**LEGEND (ALL CHANGES TO ALL LEVELS)**

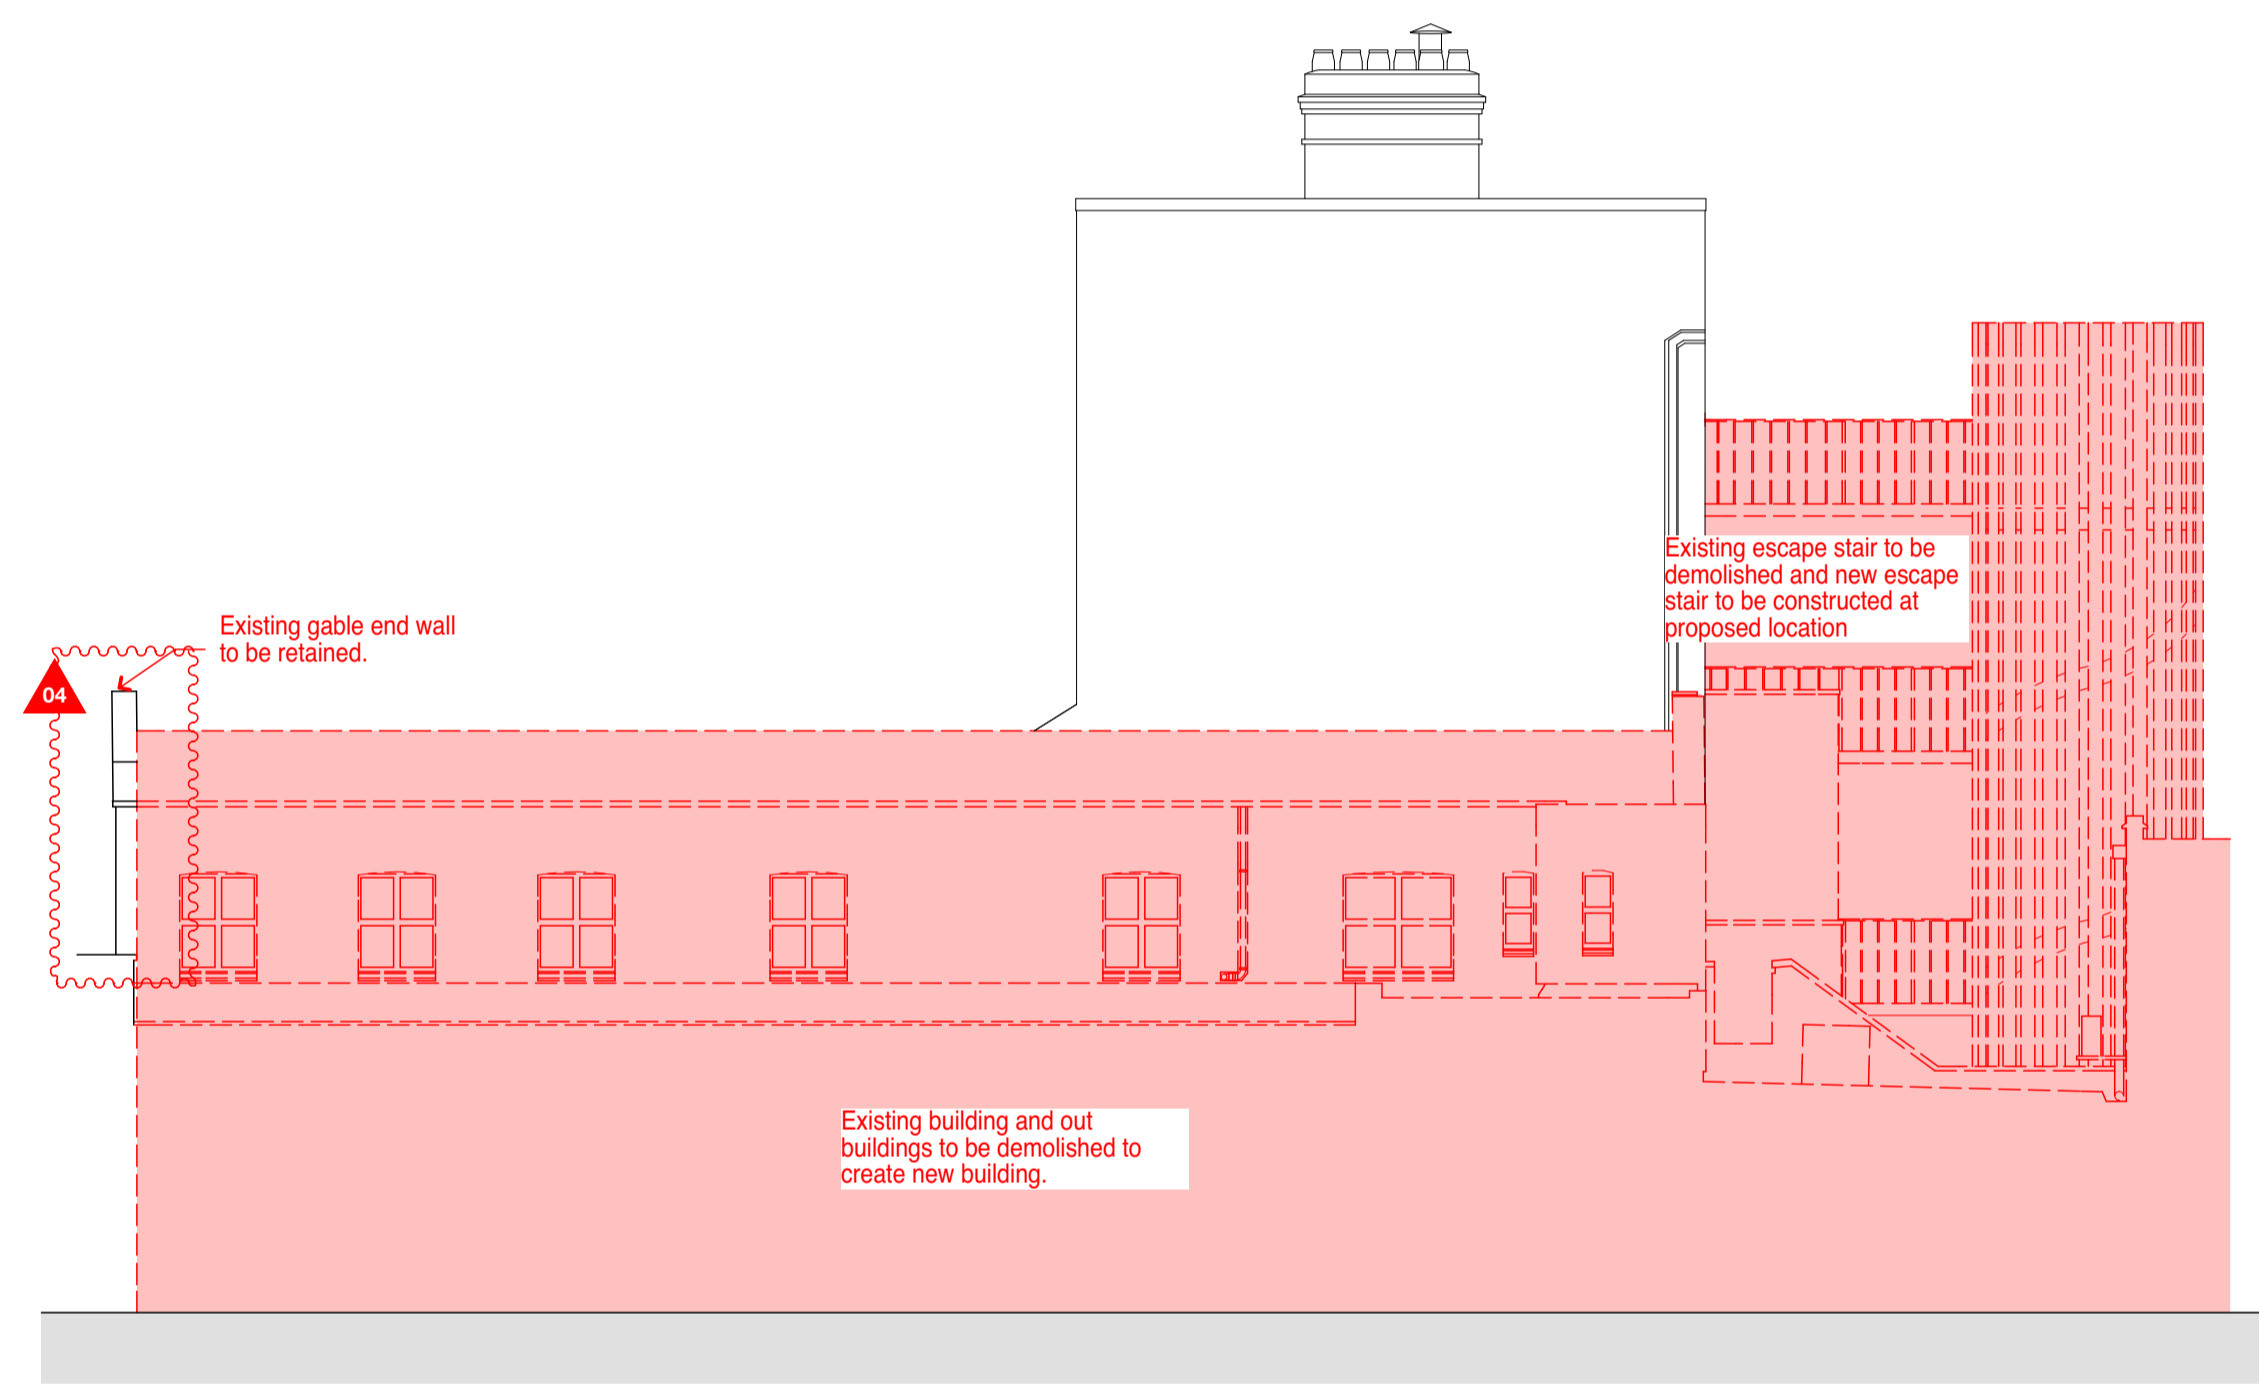
- ▲01 Stair 2 omitted, and glazed entrance enclosure enlarged
- ▲02 Window added
- ▲03 New steps to base of external spiral stair
- ▲04 Stair 3 roof and gable end arrangement revised.

- ▲05 Level 3 accommodation mansarded
- ▲06 Roof light size, height and position adjusted, and smoke vents added.
- ▲07 Louvres omitted.
- ▲08 Roof light size, height and position adjusted.

- ▲09 External ramp adjusted, and railings added.
- ▲10 West stair core glazing fenestration adjusted to suit amended stair landing levels.
- ▲11 External paving levels in courtyard raised to achieve required paving falls.

- ▲12 Low brick plinth added to base of external walls to TP2.
- ▲13 Brick plinth added to base of existing buildings within courtyard.
- ▲14 New steps and landing outside room G1.

- ▲15 Bin store enlarged and repositioned.
- ▲16 Gallery passageway to TP2: finishes revised.
- ▲17 Gallery passageway; entrance gates design revised.
- ▲18 Window on north elevation of TP2 reduced in length.

- ▲19 Revised turn-table size and position
- ▲20 Entrance ramp gradient and levels adjusted.
- ▲21 External levels adjusted
- ▲22 TP1 west door ramp omitted

- ▲23 Fall restraint added
- ▲24 Gates removed
- ▲25 Maintenance access door added
- ▲26 Parapet revised
- ▲27 Roof/wall shape adjusted
- ▲28 TP1 reception relocated

- ▲29 Revised door design
- ▲30 Modifications to windows, doors and facades facing into courtyard.
- ▲31 Gate details revised
- ▲32 Revised proposal for bike storage replacing existing bike racks in Dairy shed.

- ▲33 Gate retained and modified
- ▲34 Bike canopy detail revised (typical condition highlighted)
- ▲35 Sub-station doors revised
- ▲36 Steps adjusted
- ▲37 Cladding changed to brass finish

- ▲38 Wall mounted planters revised (typical condition highlighted)
- ▲39 Steel posts added to boundary wall (typical condition highlighted)
- ▲40 Height of glazed entrance roof increased to suit required pitch.

- ▲41 Glazed entrance roof and canopy revised
- ▲42 New roof guarding to existing flat roof
- ▲43 Screening fins and cladding added
- ▲44 Louvres added
- ▲45 Ramp omitted

- ▲46 Door removed and infilled
- ▲47 Access hatch adjusted.
- ▲48 Depth of green/blue roof build-up adjusted.
- ▲49 Blue roof incorporated into green roof and gravel margins added.

- ▲50 Cladding build-up adjusted
- ▲51 Orientation of brass seams adjusted
- ▲52 Roof gutters revised.
- ▲53 Means of escape revisited and exit door added to TP1

- ▲54 Spiral staircase landings added at each floor
- ▲55 Door modified
- ▲56 Basement louvers to external metal staircase landings
- ▲57 Revised proposal for mean of escape in TP1

- ▲58 Revised proposal for window and door
- ▲59 Revised proposal for door to be left as current
- ▲60 Gate to be removed
- ▲61 Capping width adjusted and roof planters shown indicatively.

- ▲62 Door to be replaced
- ▲63 Revised proposal for the entrance
- ▲64 Gates and Entrance door in TP1 to be replaced
- ▲65 Existing stair to be demolished

- ▲66 Existing window and door to be replaced
- ▲67 New reconfiguration for new spiral stair and WC
- ▲68 Staircase partially demolished
- ▲69 Level adjusted

- ▲70 Lift pit adjusted
- ▲71 Level updated
- ▲72 Red line extended to include South Crescent Mews
- ▲73 Red line extended to include new ramp and frontage

- ▲74 Ladder added
- ▲75 Works to Mews paving/kerbs added
- ▲77 Minor adjustment to ridge, and eaves line, (not affecting ridge level noted on consented drawings).
